# 2018 International Residential Code Changes Related to Wood Construction

**Appendix: 2018 IRC Changes Related to Wood Construction –  
Strikethrough/Underline Format**

**FIGURE R507.5 R507.6**

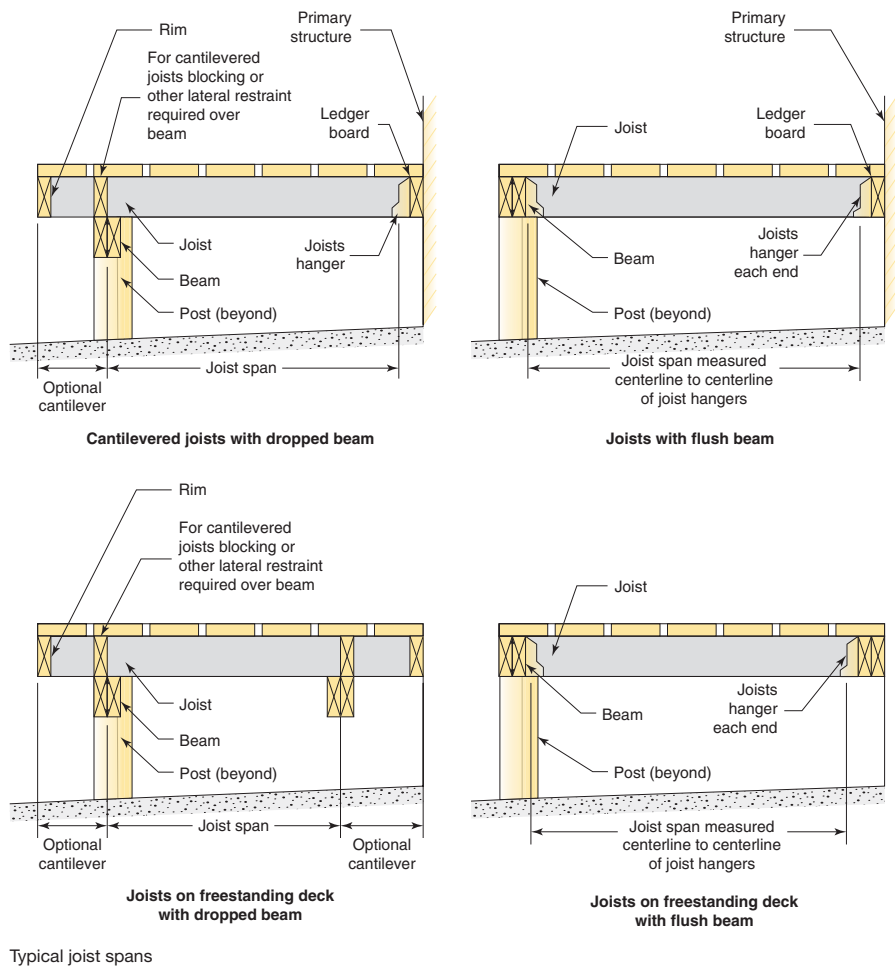
- o Deck joist span table and diagrams were revised, reflecting in part the AWC *DCA-6 Prescriptive Residential Wood Deck Construction Guide*, notably with a modification to clarify maximum cantilever spans [RB210-16].

**TABLE R507.5 R507.6 DECK JOIST SPANS FOR COMMON LUMBER SPECIES (ft.-in.)**

**IRC Figure R602.7.2 RIM BOARD HEADER CONSTRUCTION**

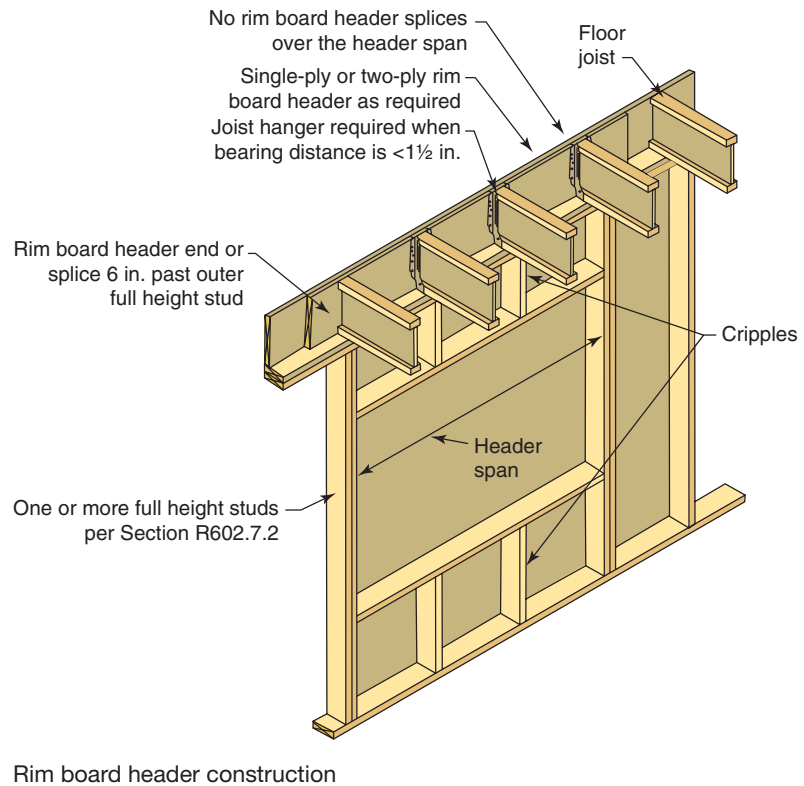
- A technical error in Figure R602.7.2 for rim board header construction was corrected and the construction detail call-outs were improved [RB228-16].
- The number of full height studs required to be provided at openings was reduced to correct unnecessary conservatism and the associated Table R602.7.5 Minimum Number of Full Height Studs at Each End of Headers in Exterior Walls was simplified [RB229-16].
